# Access Compliance Report

## Public Rights-of-Way

### (Pedestrian Signals)

Intersection ID: N/A	Main Street:	Cross Street: N/A	Location: N/A
ADA ID: 20B3C92CD073	Signal Type: One Push Button-Non APS	Overall Compliance: No	Severity Score: BTN 1: N/A BTN 2: N/A No BTN: N/A
Codes/Mitigation Info/Possible Solution		Field Measurements/Component Compliance

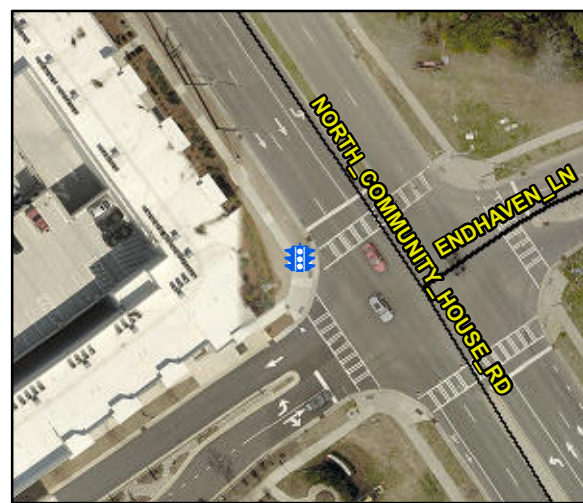
Possible Solutions: Replace Signal Push Button With APS Button on New Post. Remove & Relocate Sign.

PROW/ADA: TMUTCD 4e.08, R406.2
